**Turtle Creek No. 3 Primary Pump Station Project**  
**Solicitation Number: CO-00404-SM**  
**Job No.: 21-6001**

**ADDENDUM NO. 5**  
**September 22, 2021**

| SHEET   | CH-4     |                |           |          |     |       |           |           |                      |

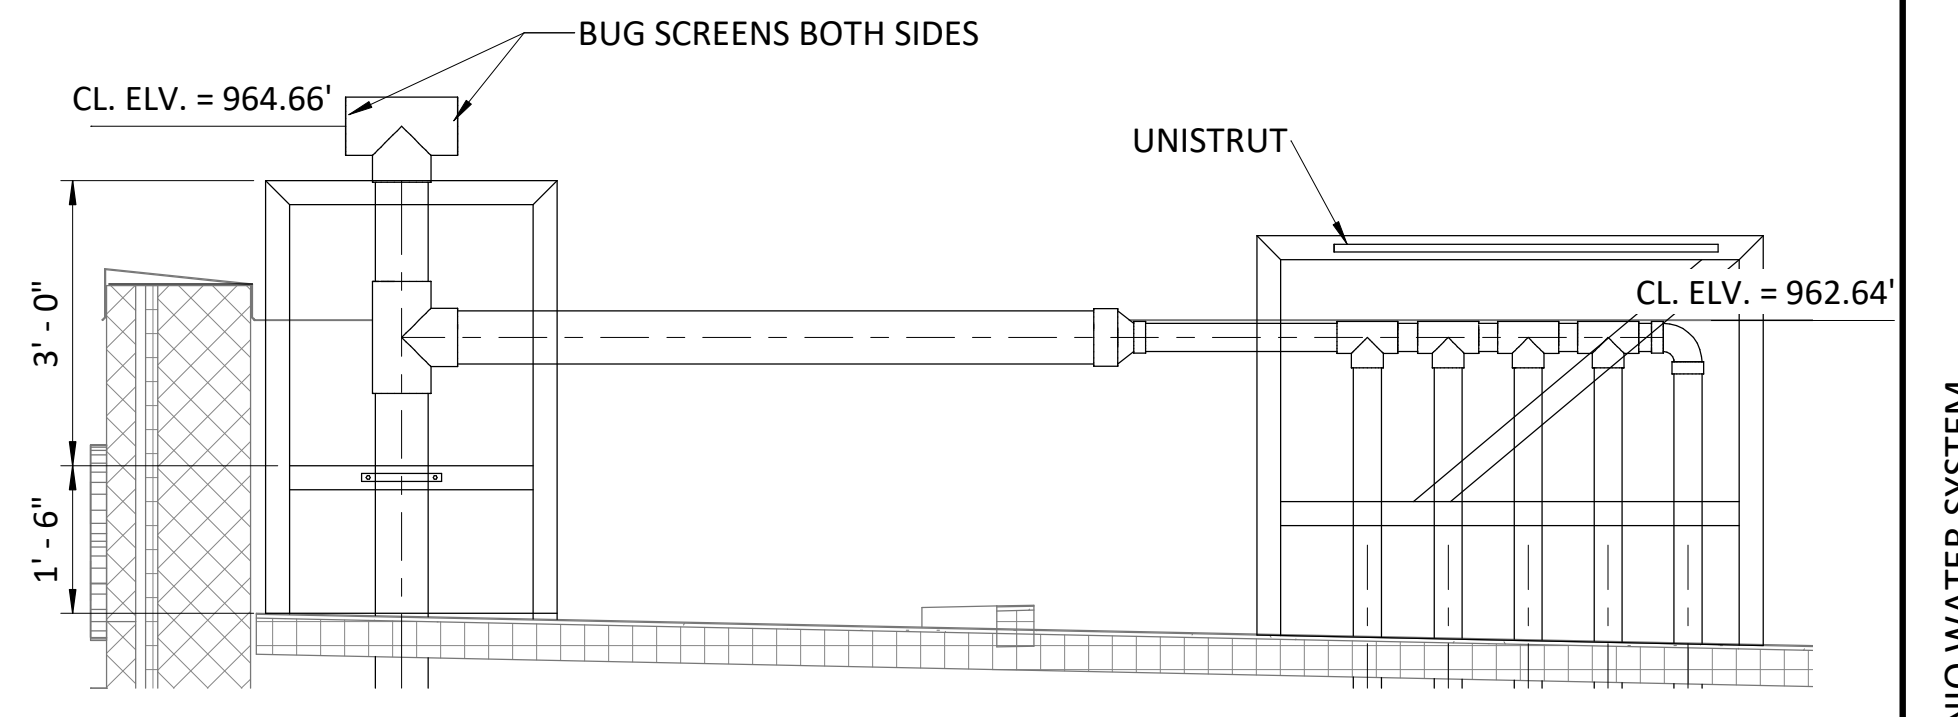
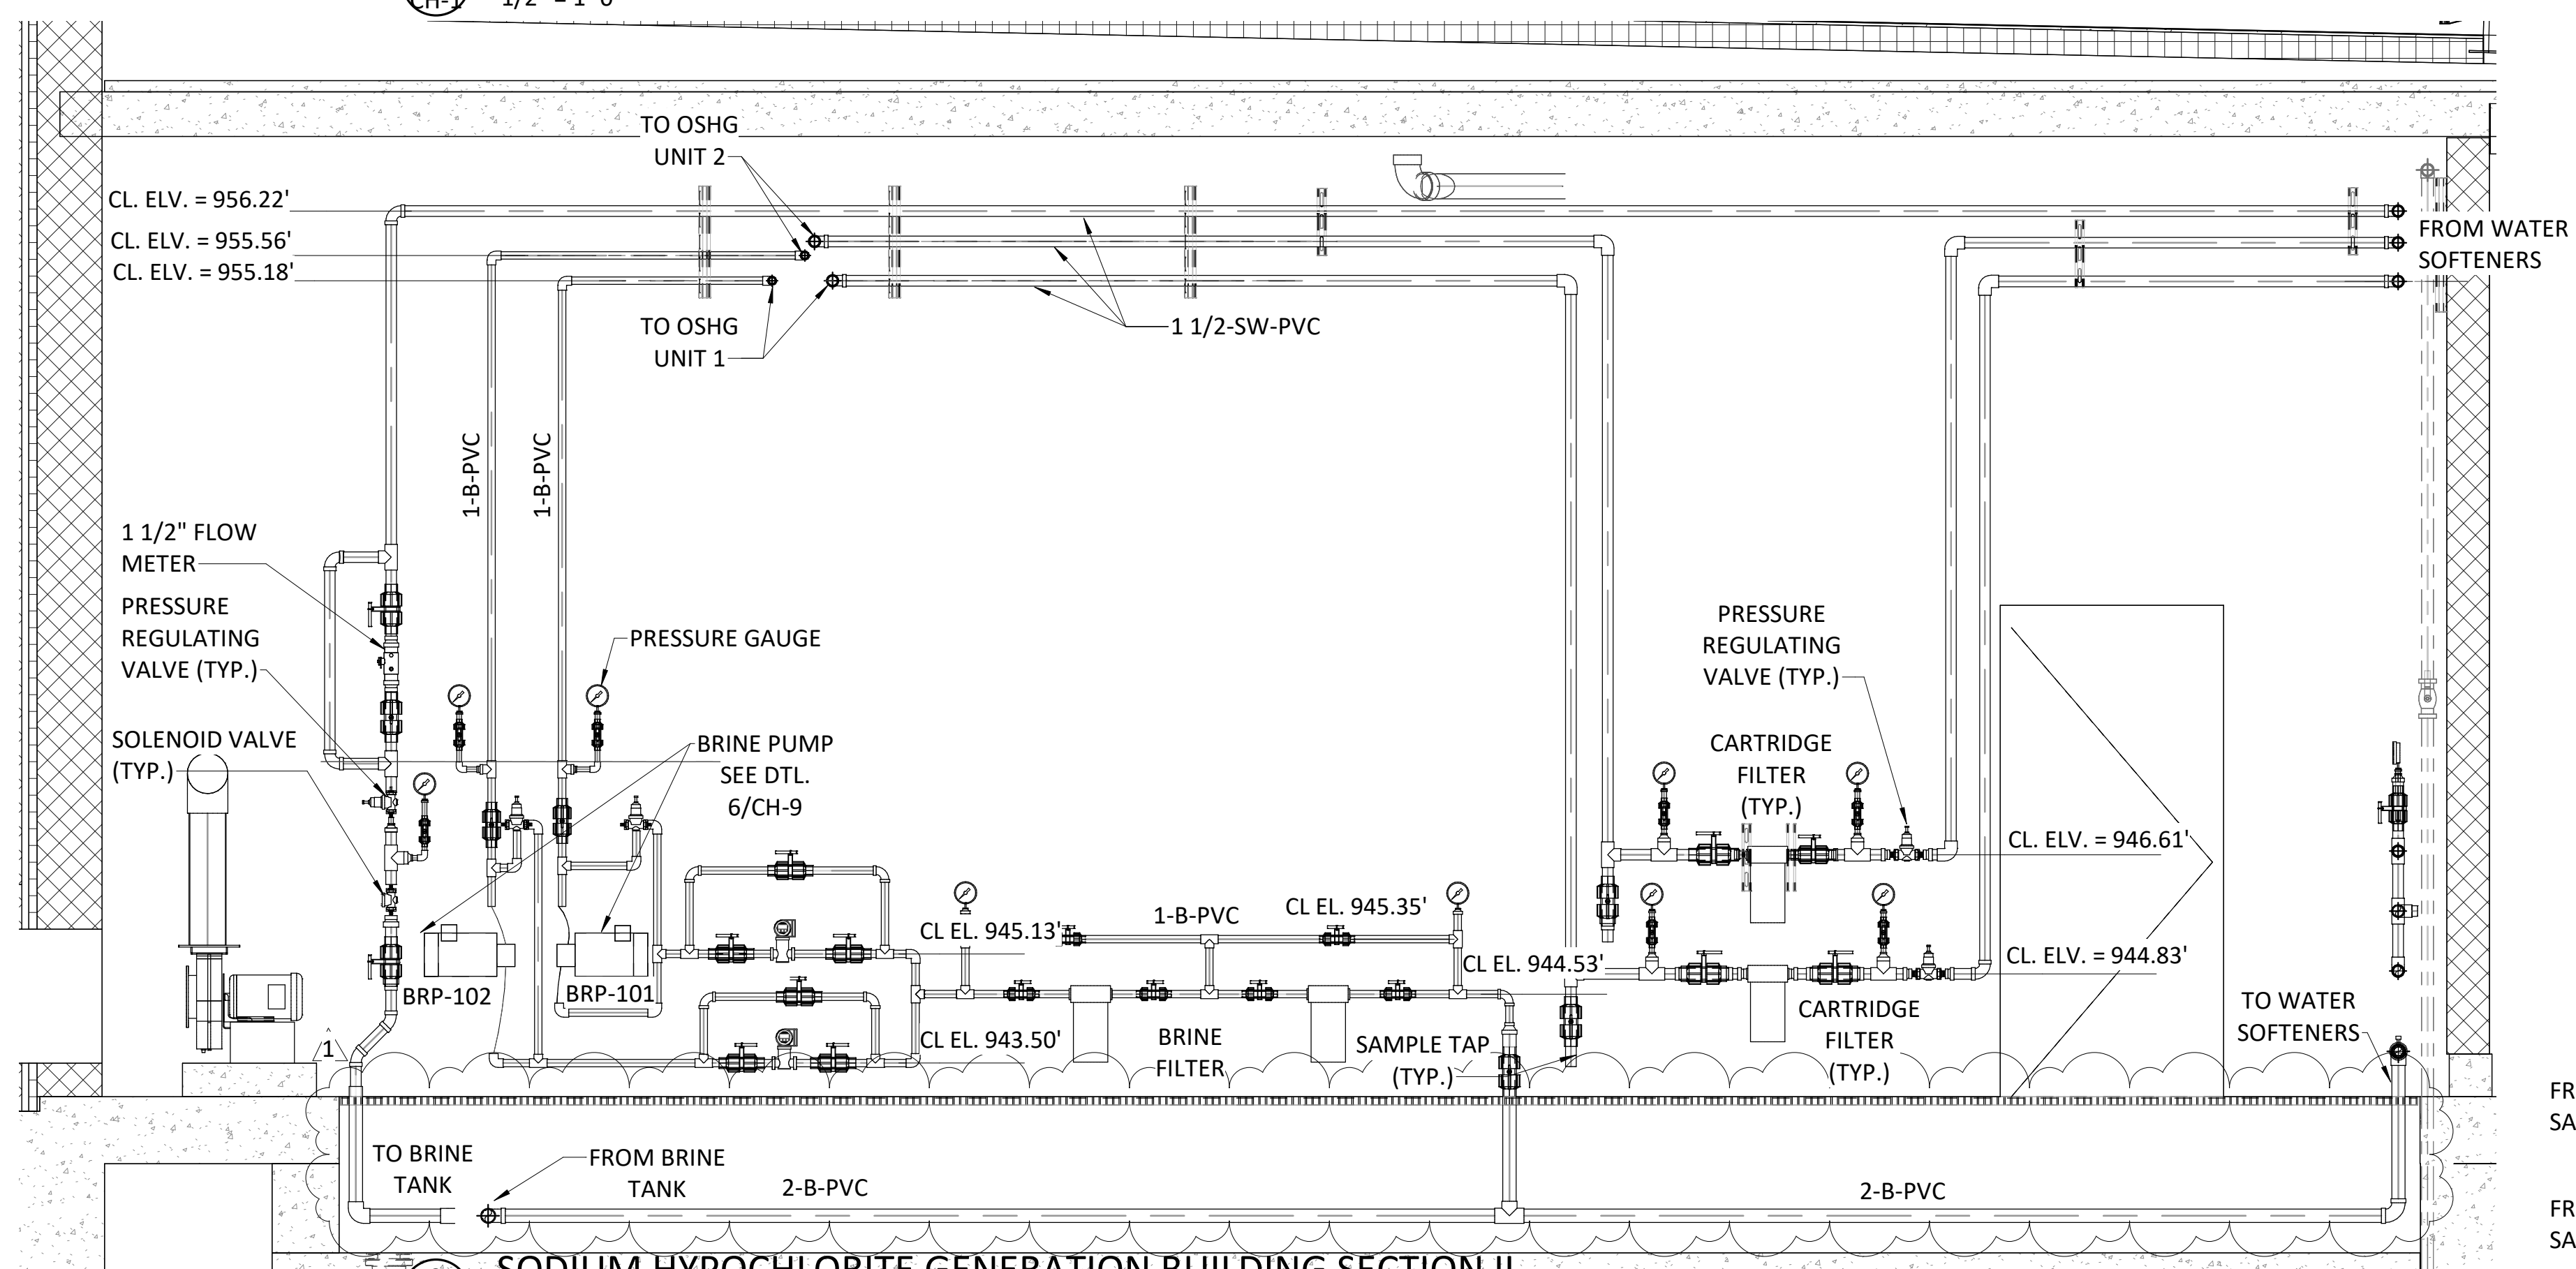
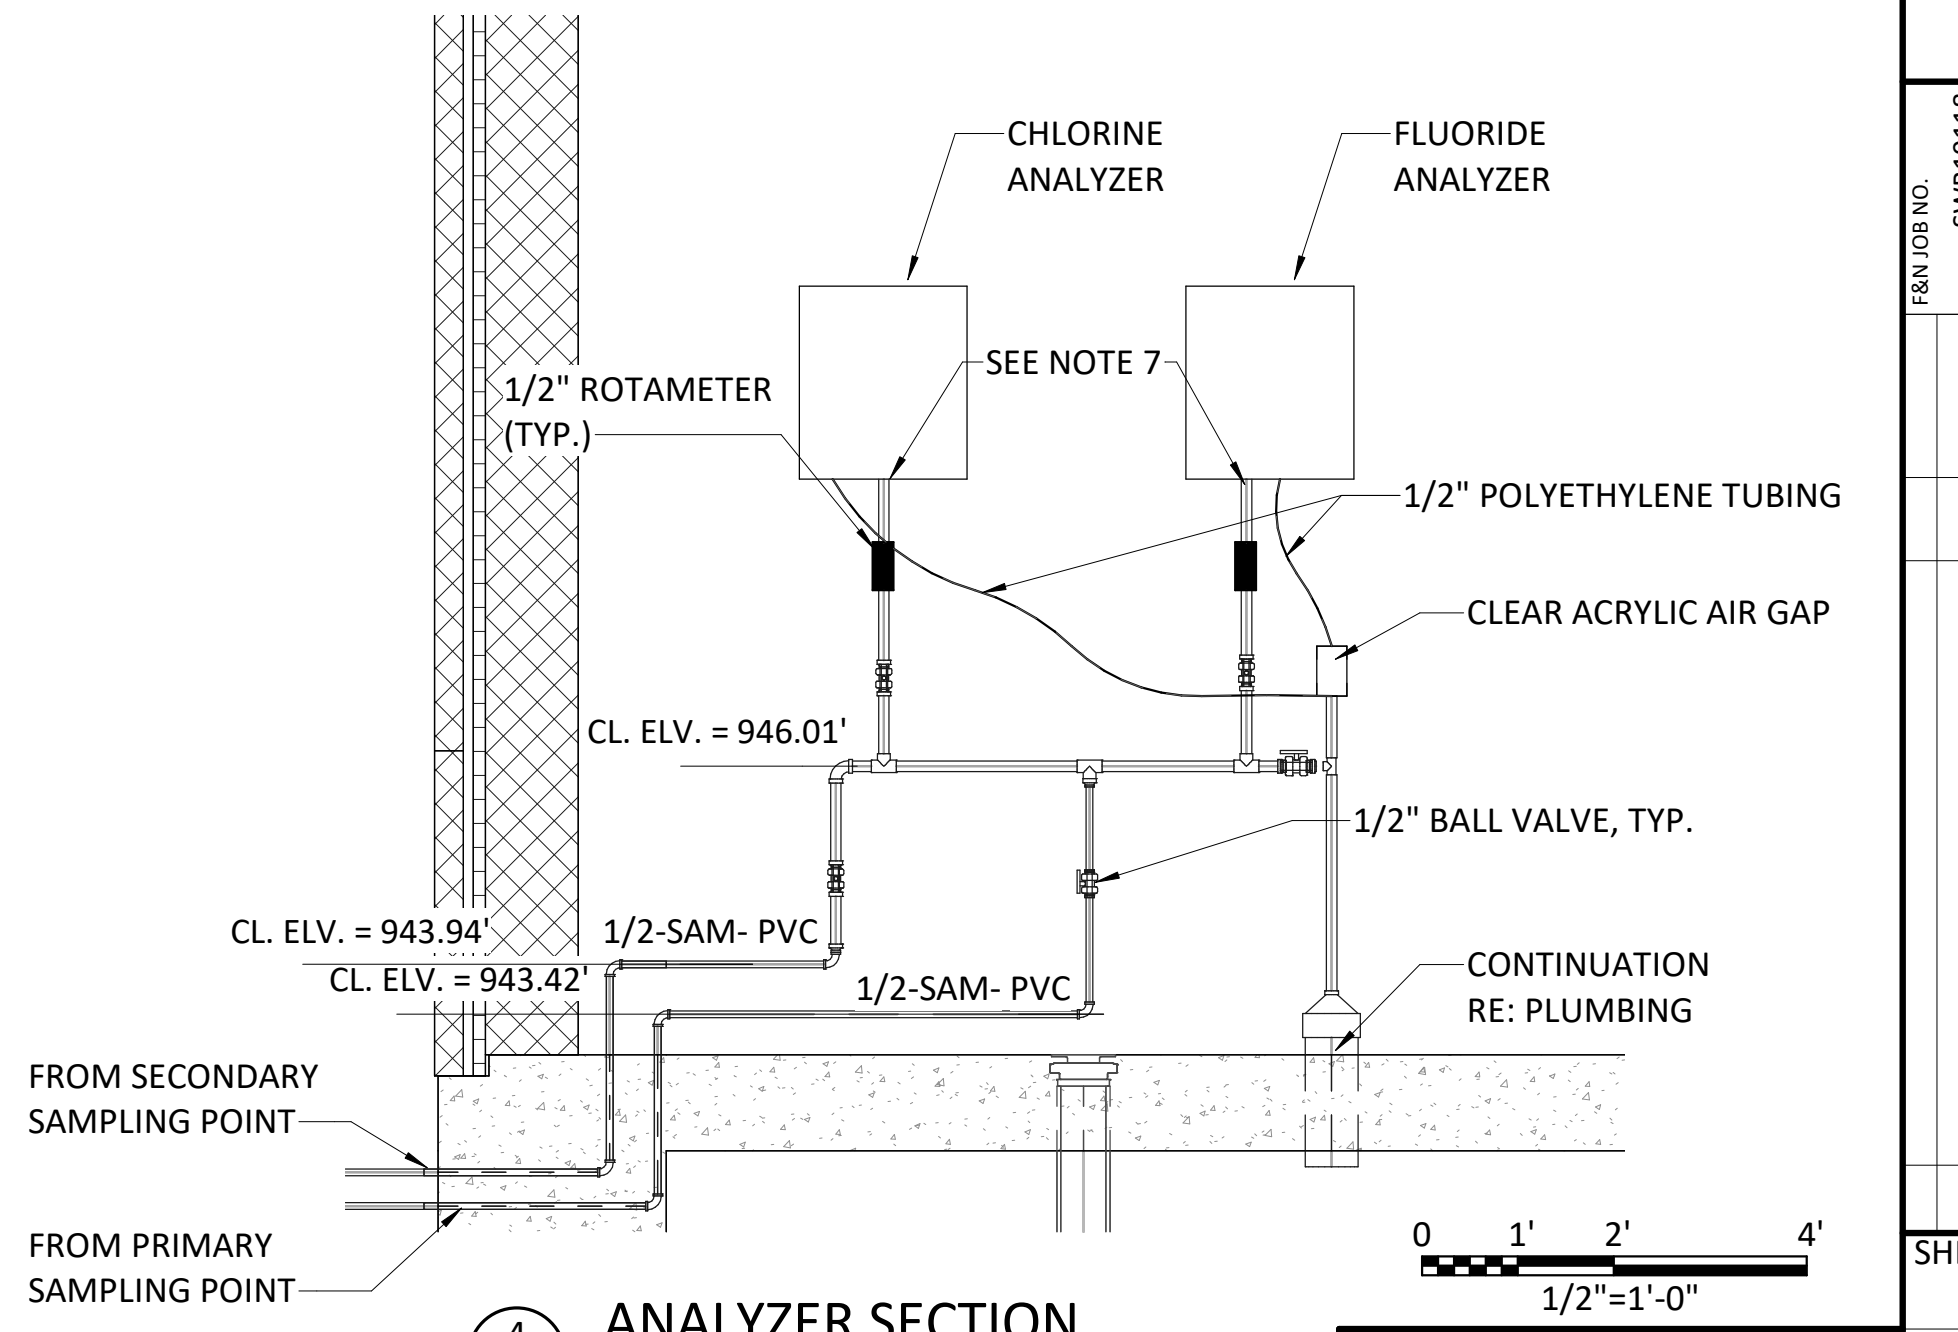
- 39. Question: DWG CH4 SHOWS NOTES INDICATING " FROM BRINE TANK" & 2-B-PVC, BUT NOTHING IS SHOWN. CAN YOU PROVIDE THE FULL SECTION DWG TO SHOW THE MISSING PIPE?**

*Response: Refer to Item No. 6 in the CHANGES TO THE PLAN SECTION of this addendum.*

5. **Delete** Drawing PS-2 in its entirety **and replace with** revised Drawing PS-2 included in this addendum.
6. **Delete** Drawing CH-4 in its entirety **and replace with** revised Drawing CH-4 included in this addendum.
